# **Attachment A**

## **Building Envelope Modification Design Report**

Henning Larsen Architects have prepared a detailed building design for the Cockle Bay Park development as part of the application.

# Compliance Clarification: South Landscaping

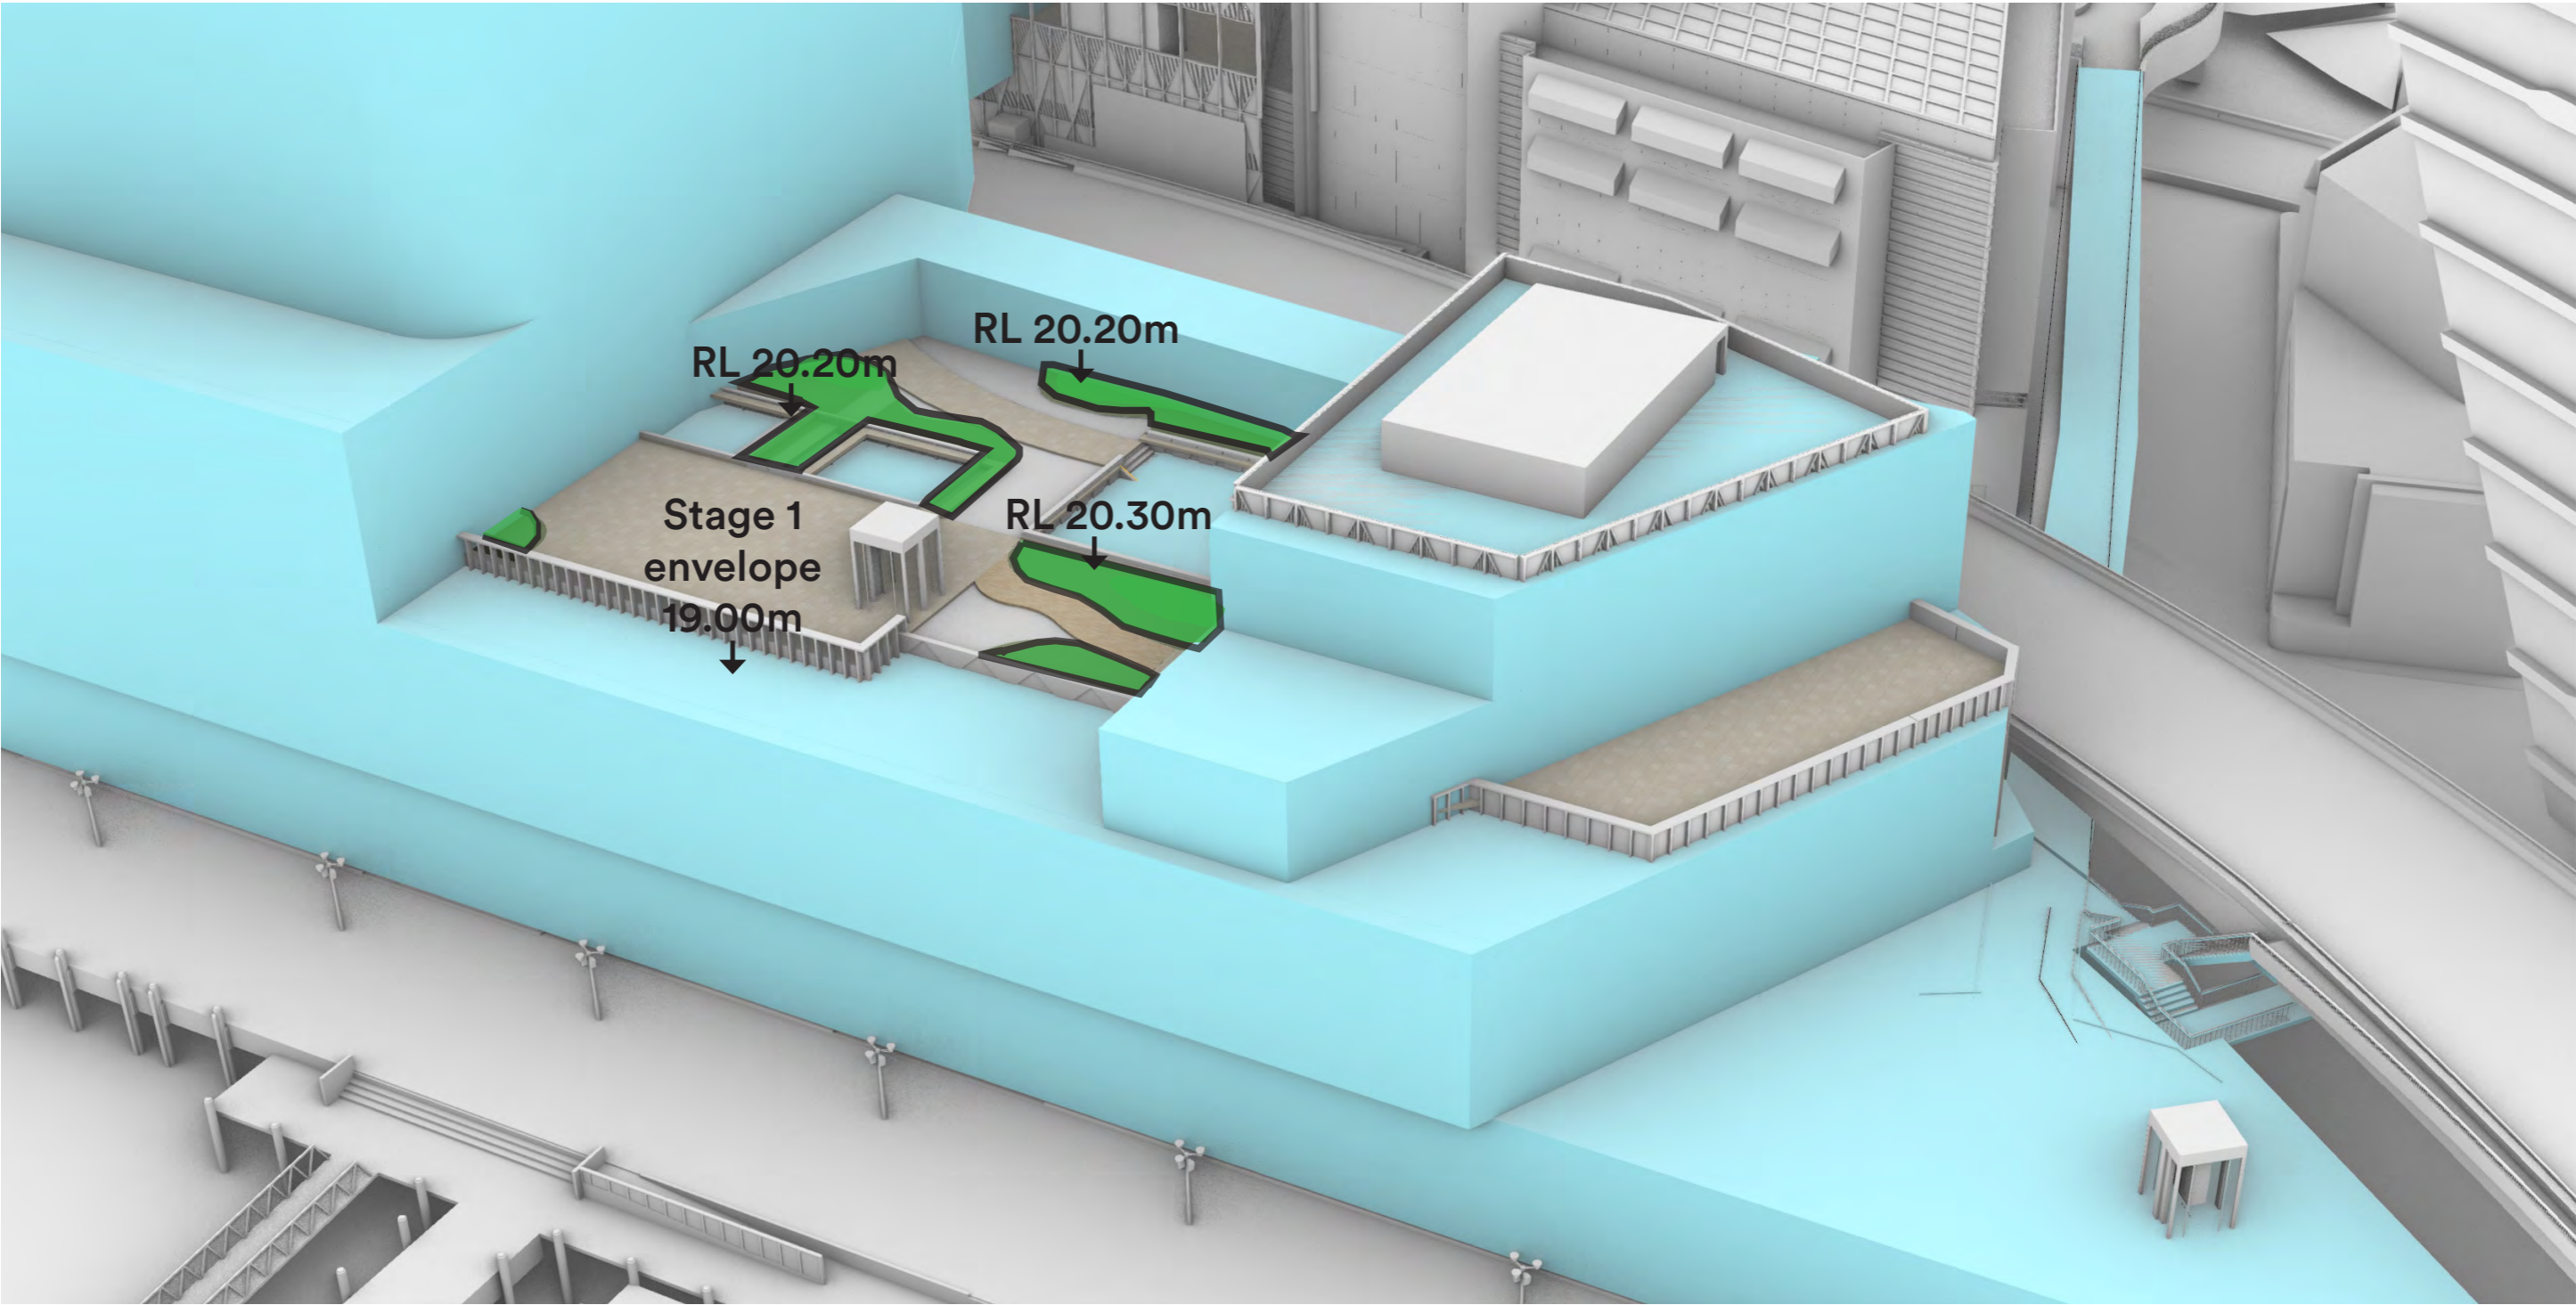
The Concept (Stage 1) DA permits balustrades(parapets) and vegetation to extend beyond the building envelope where these components are within, and relate specifically to, the publicly accessible open space or the public domain. Those components of the level change that solely relate to the build-up of soft materials for vegetation would comply within the permitted exemptions.

# Compliance Clarification: North Landscaping

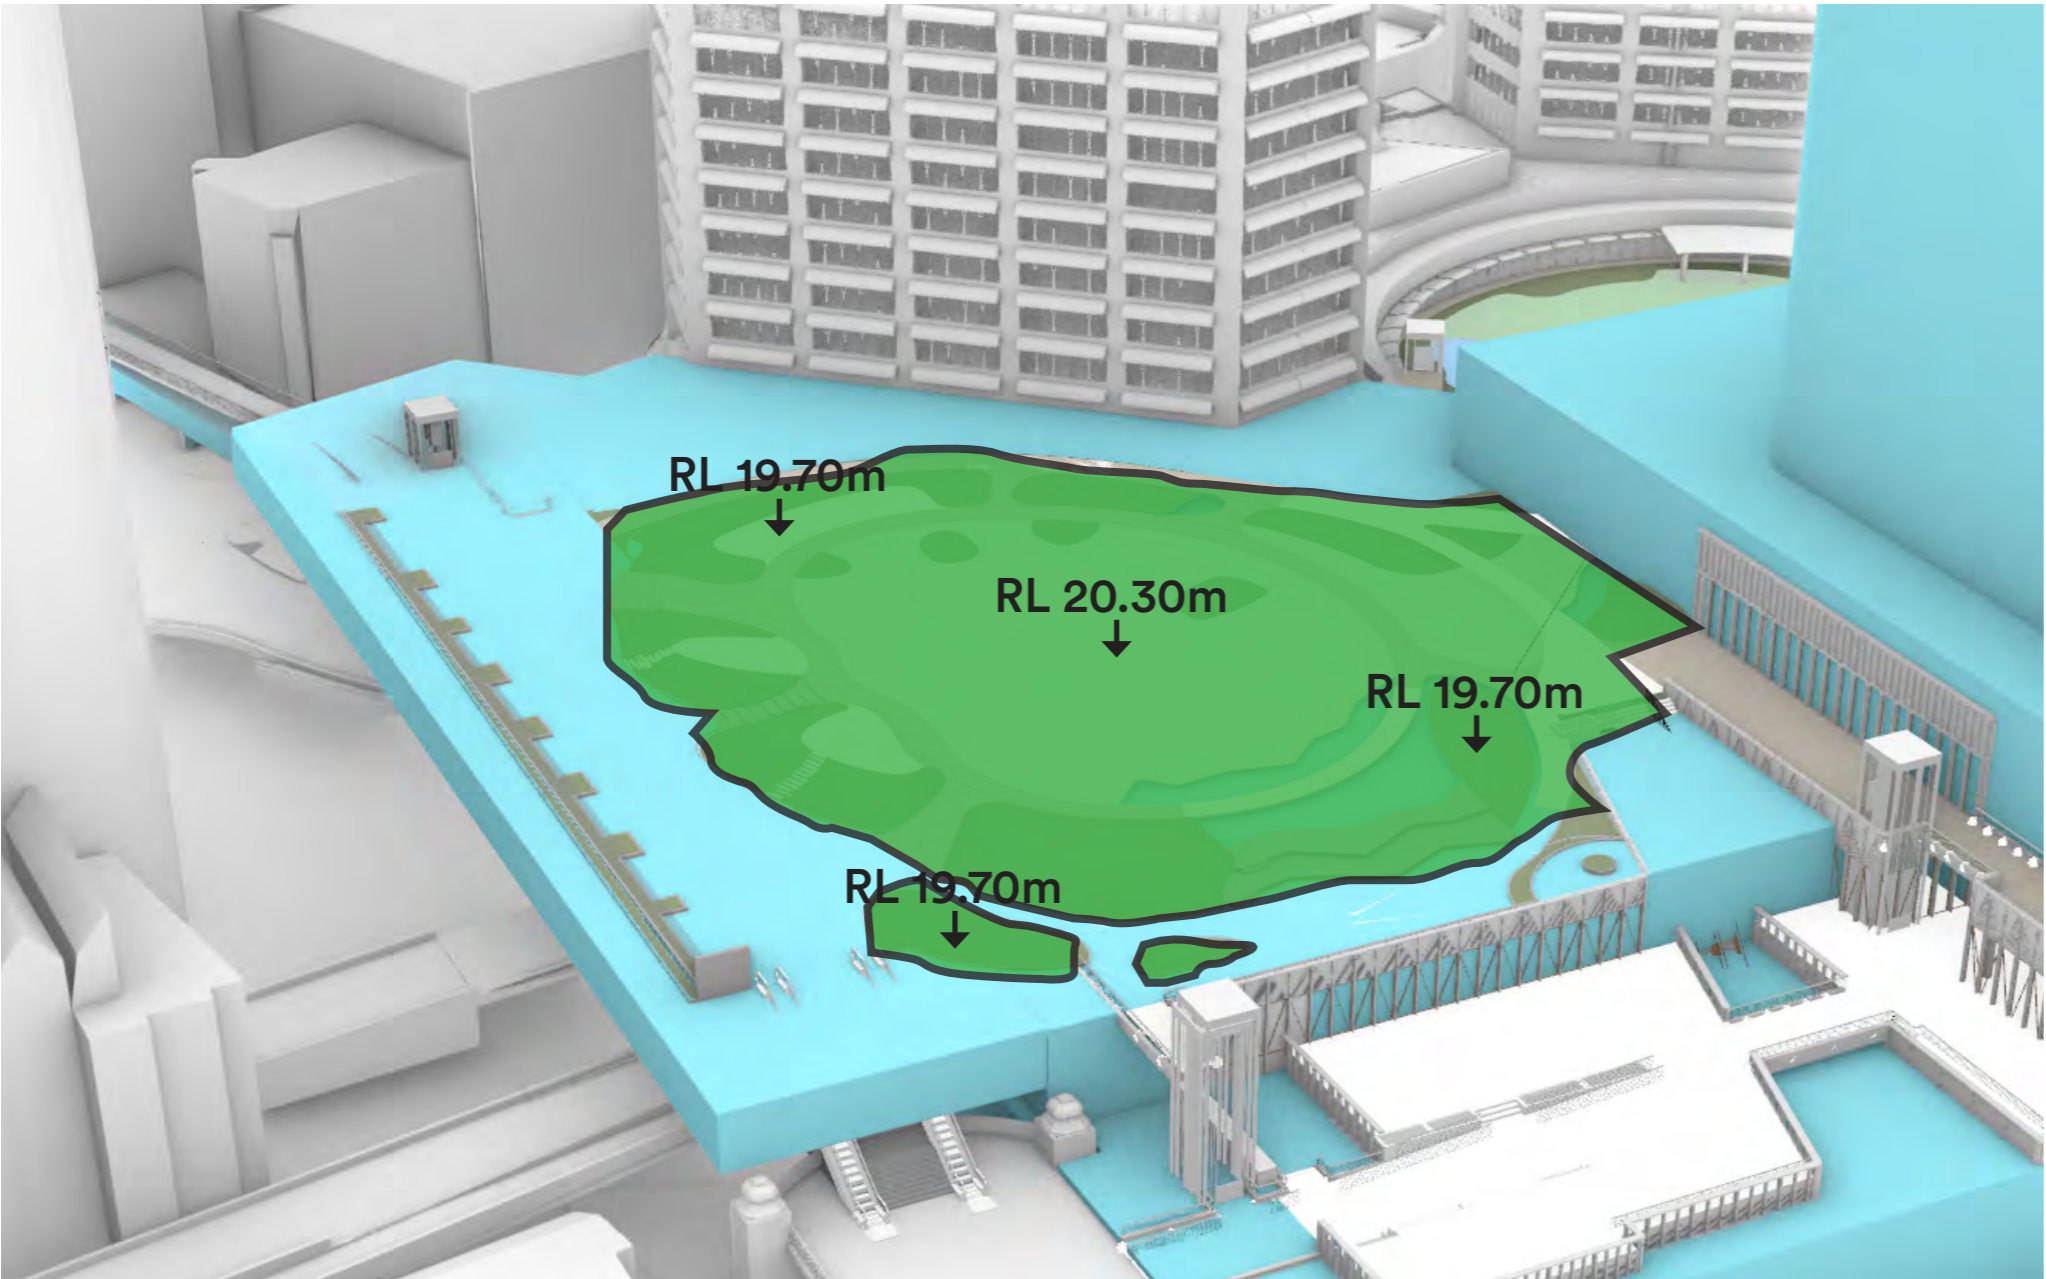
The Concept (Stage 1) DA permits balustrades(parapets) and vegetation to extend beyond the building envelope where these components are within, and relate specifically to, the publicly accessible open space or the public domain. Those components of the level change that solely relate to the build-up of soft materials for vegetation would comply within the permitted exemptions.

# Compliance Clarification: Public Pergolas/Shading

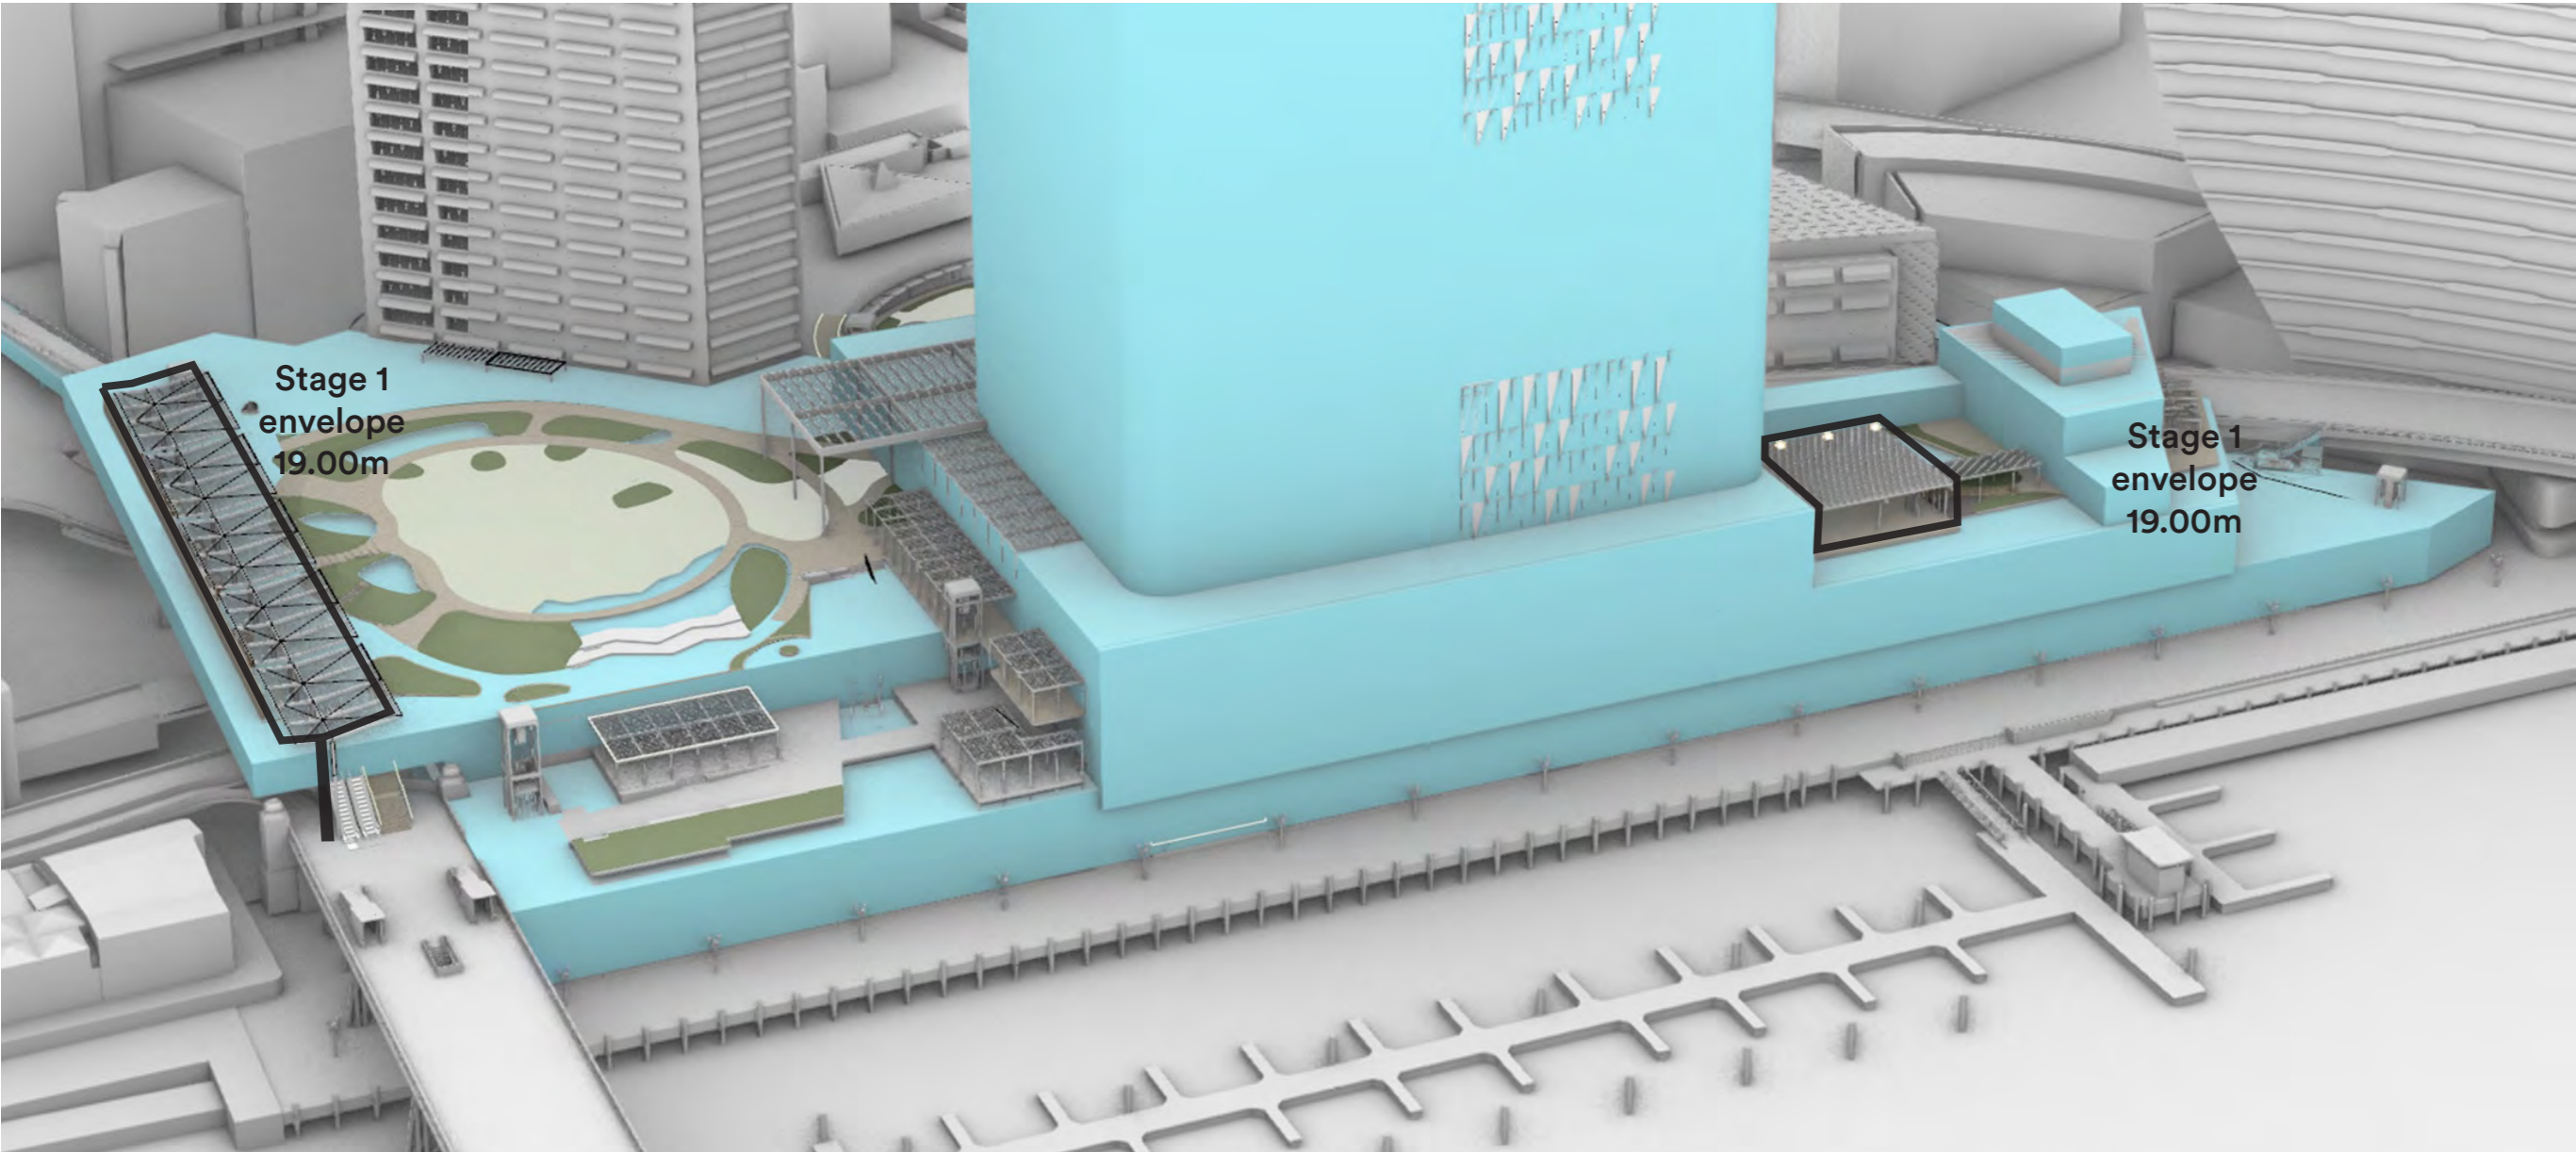
The Concept (Stage 1) DA permits garden pavilions and kiosks beyond the building envelope where these components are within, and relate specifically to, the publicly accessible open space or the public domain. The proposed pergolas are associated with the Northern and Southern park spaces and, therefore, are aligned with publicly accessible open space and public domain areas. In the case of the pergolas within the public domain, these refinements, therefore, would fall within the permitted exemptions and are appropriate and supportable.

Others pergolas around the base of the Tower provide much needed solar shading and climate comfort to external areas. They also shelter vertical transport elements, such as escalators, from the rain. The pergolas close to the Tower help to reduce down draught from winds around the Tower.
